SUBJECT: Proposed revisions to NSF/ANSI 55: *Ultraviolet Microbiological Water Treatment Systems* (55i65r1)

NSF/ANSI Standard for Drinking Water Treatment Units –

Ultraviolet Microbiological Water Treatment Systems

Figure 2
Collimated beam apparatus

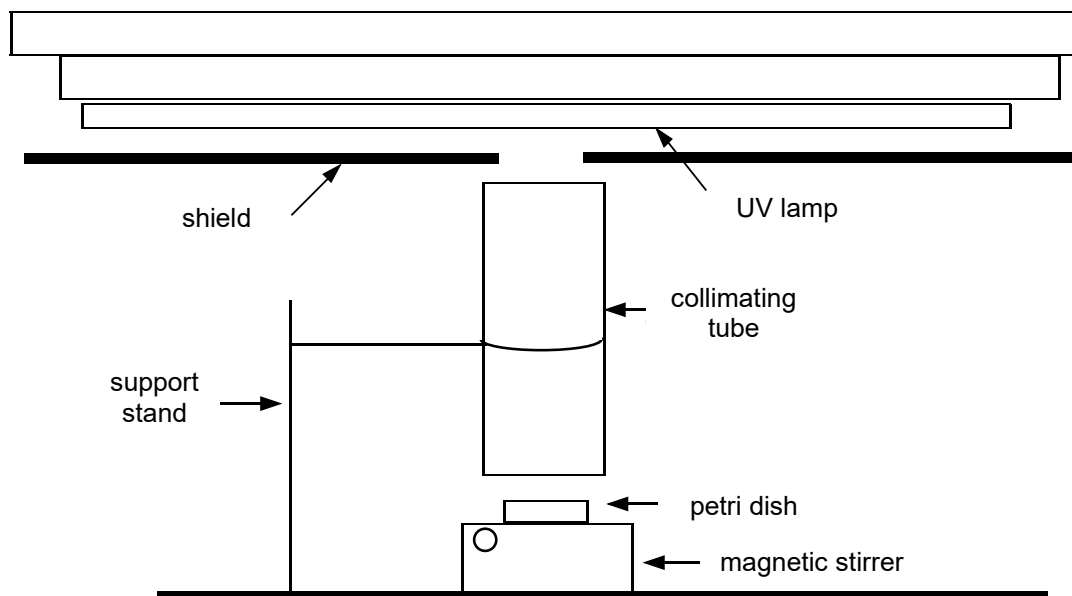
- the pathlength of the ultraviolet light column shall be a minimum of 53 cm (21in) in length and the interior shall be painted flat black. The light pathlength ~~shall~~^{must} also be at least 6 times the diameter of the suspension's surface;
- the support stand, if used, shall be adjustable to raise or lower the collimating tube to the surface of the petri dish;
- the petri dish shall be set so the surface of the liquid is at the same level as the radiometer; and
- measurement of the UV dose shall be done at the same point at which the petri dish surface is exposed.

Rationale: *Changes normative language from “must” to “shall”.*
